STATE OF NORTH CAROLINA
DEPARTMENT OF TRANSPORTATION

March 30, 2015

Subject: **Request for Modification to Individual Section 404 and Section 401 Water Quality Certification** for the proposed NC 133 Connector from NC 211-133 (Southport Supply Road) to NC 87-133 (River Road), Brunswick County. Federal Aid Project No. STP-133(3), Debit \$570.00 from WBS No. 34531.1.1, TIP R-3324

PERMIT DRAWING
SHEET 25 OF 34
 Revised: 3/24/15

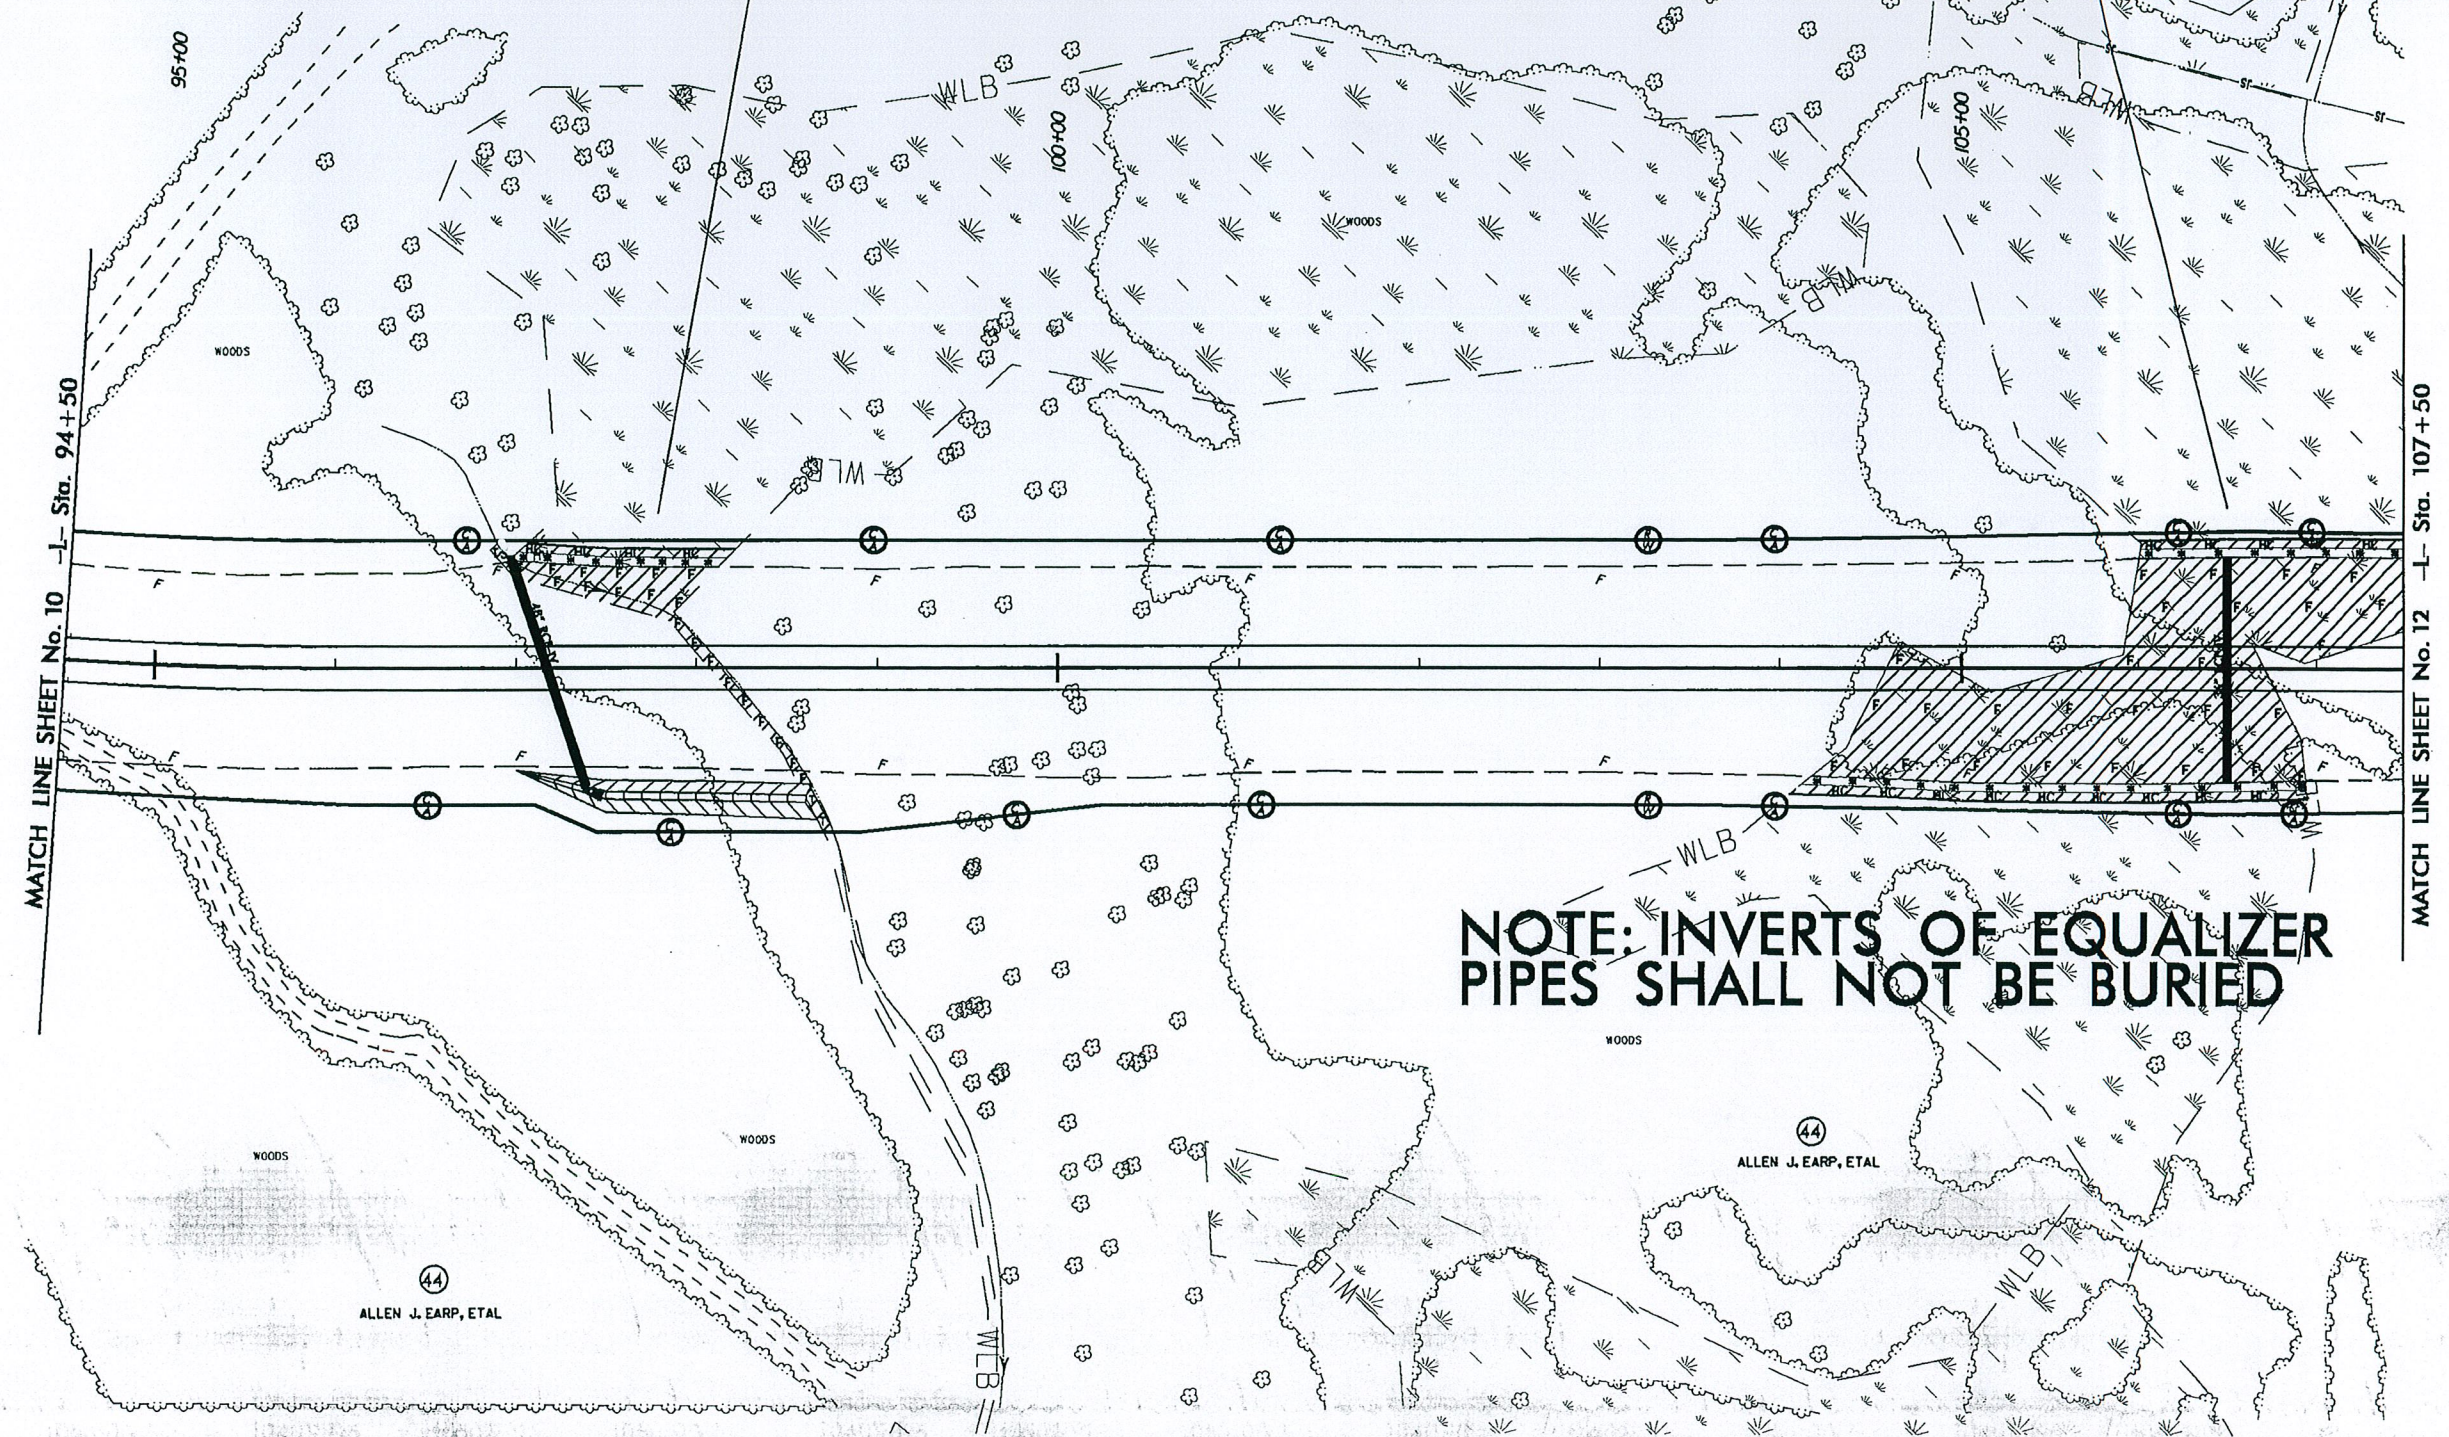
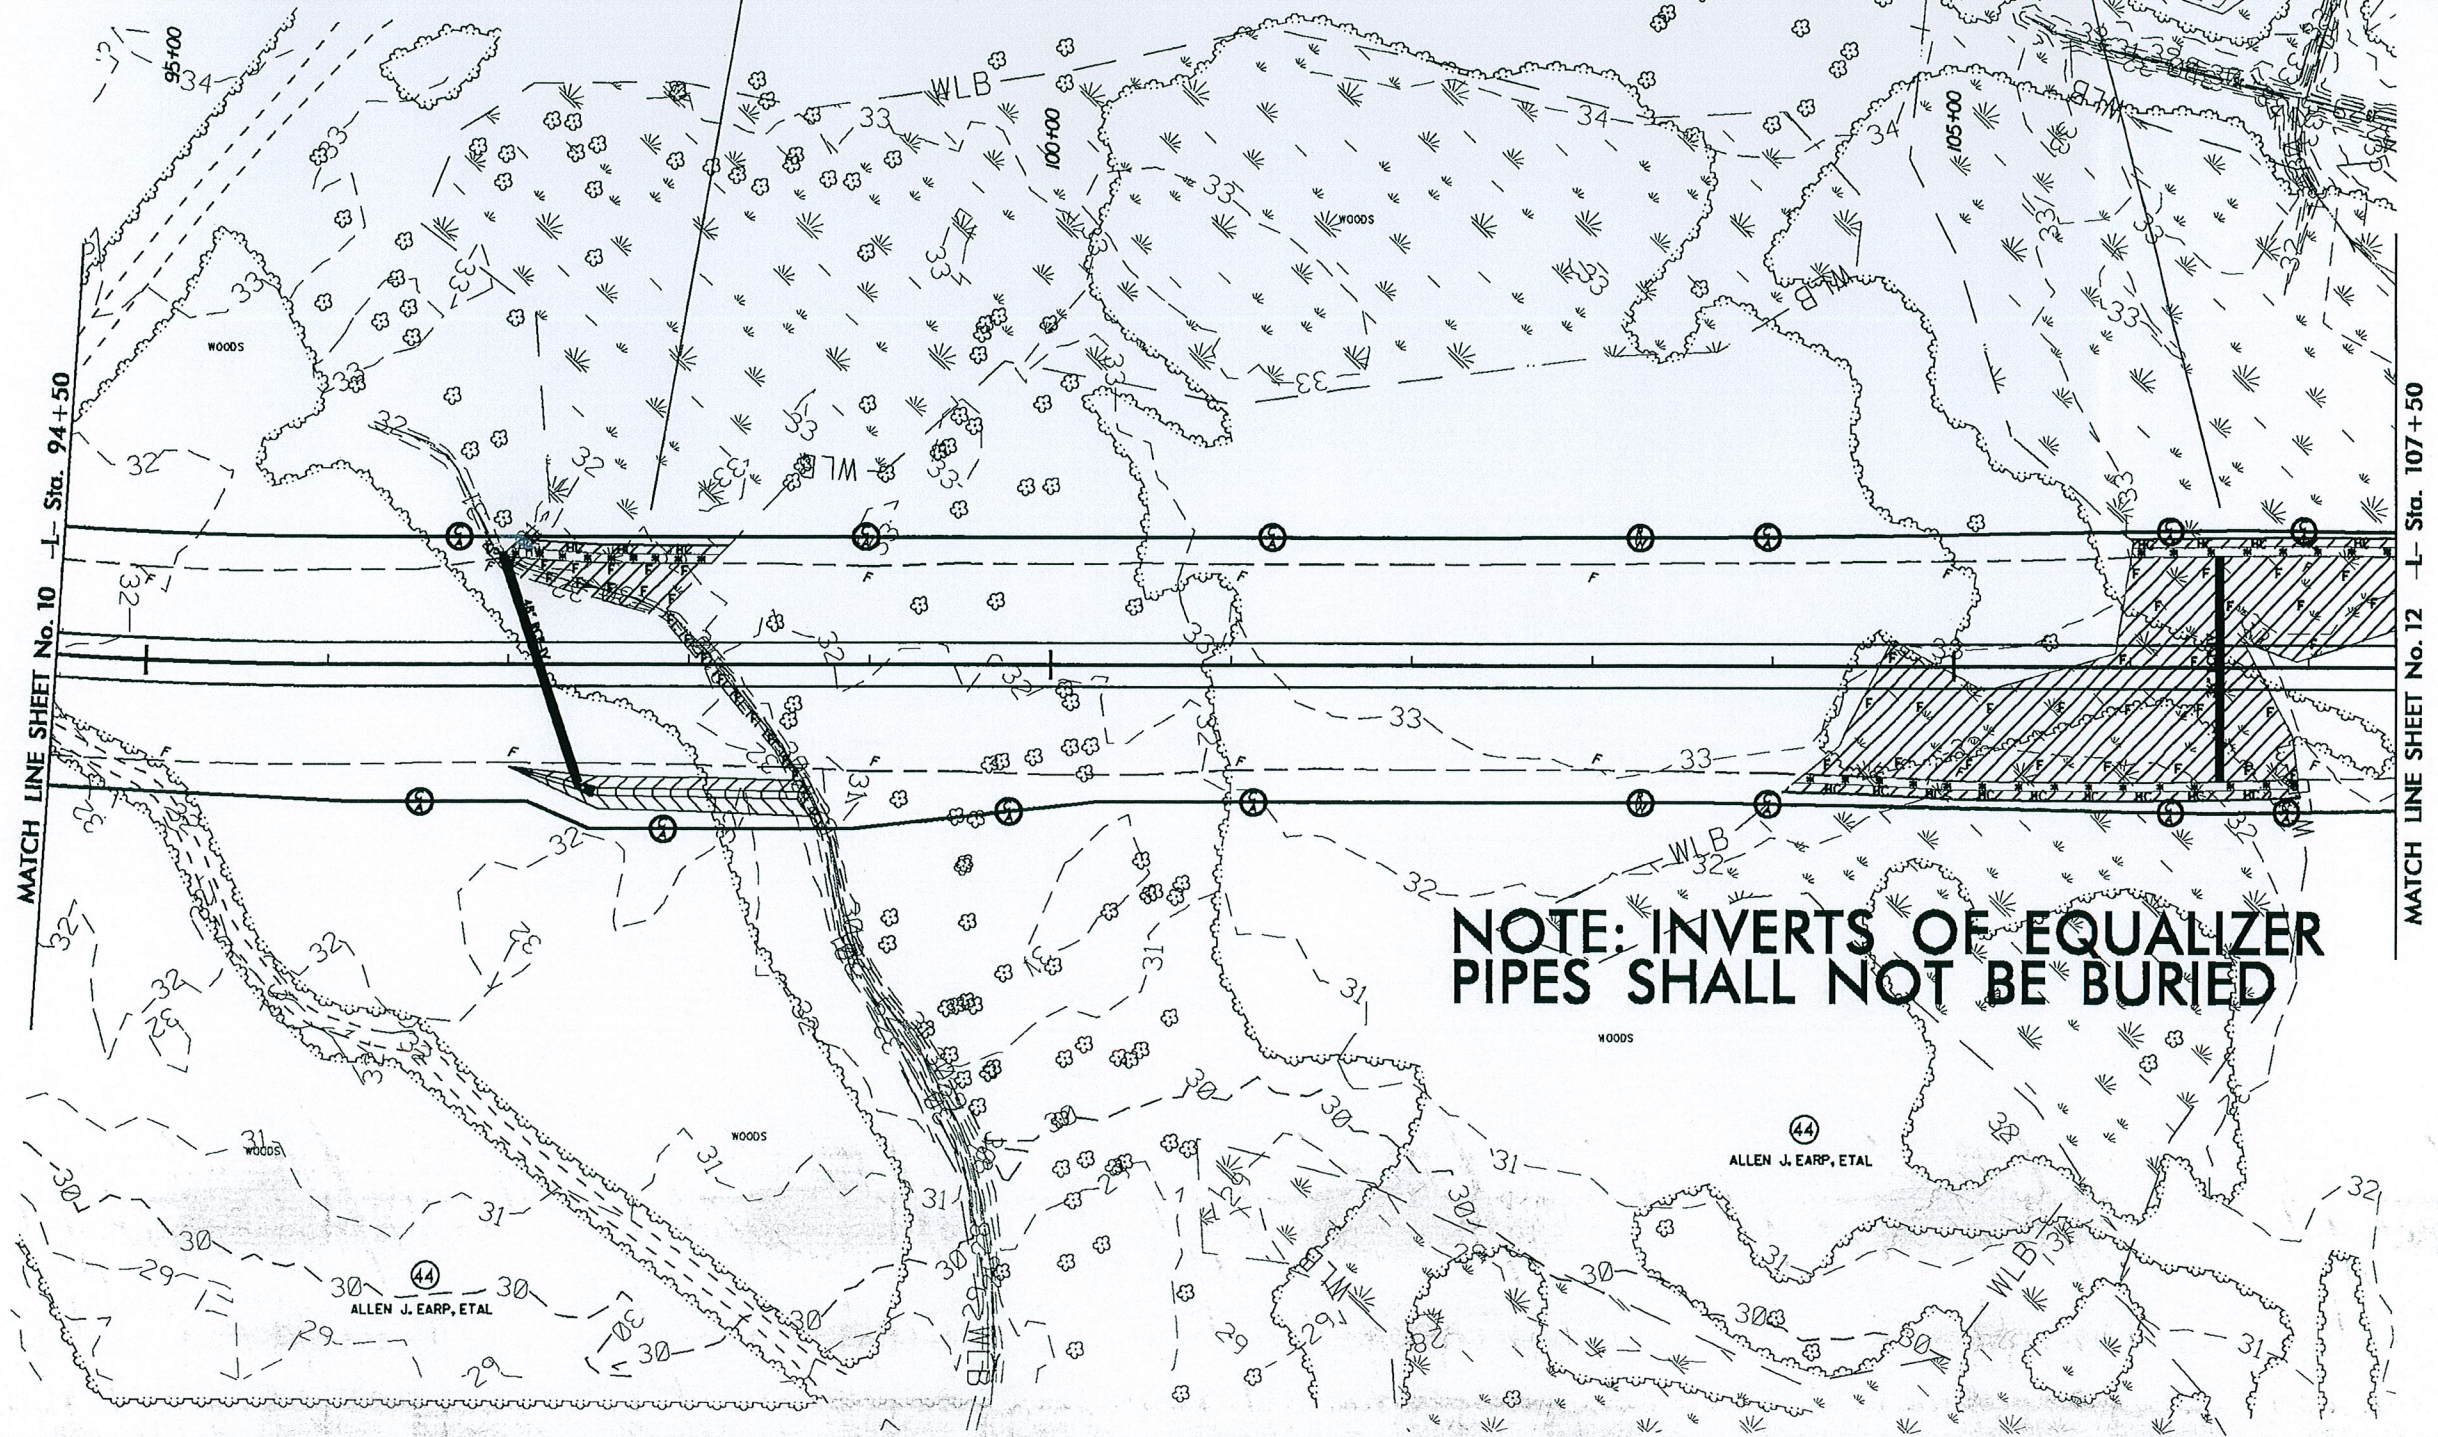
Site #6 permit drawings are now included to accompany the previously provided increase in impacts at the site. At the suggestion of the USACE, Site #7 was changed back to its original depiction. At the request of NCDOT Division 3 staff, Site #12 permit drawings (dated 3/2/2015) have not change from our March 5, 2015 submittal due to that area already being partially
